Subject: RE: WG(trans-alle)L'Horizon Terrace Glazing [#2334585] #p
Date: Thursday, 29 January 2026 at 11:31:23 Greenwich Mean Time
From: William Abbott
To: Rachel Baugh
Attachments: ATT00001.png, 504377675_Export (1).pdf

Changes to be made on config:

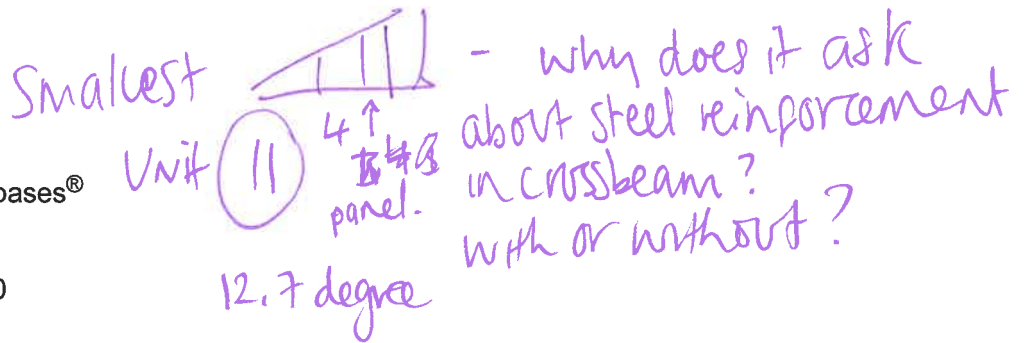
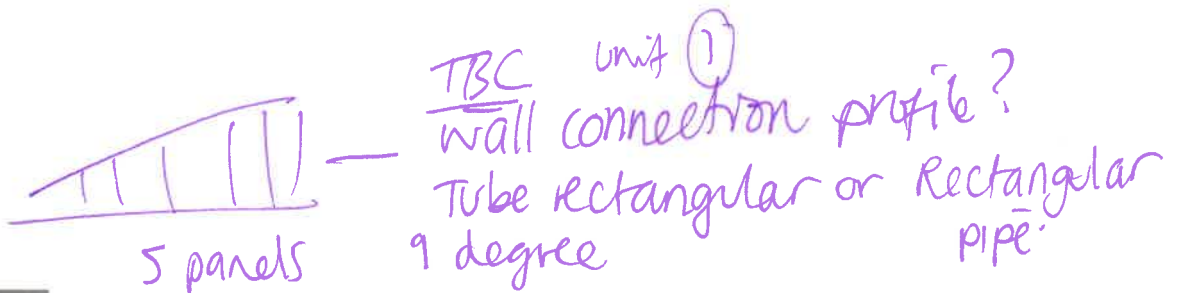
Pos 9 colour wt029/10797 4

Pos 10 colour wt029/10797 4

Pos 11 colour wt029/10797 3 leaves - + threshold profile
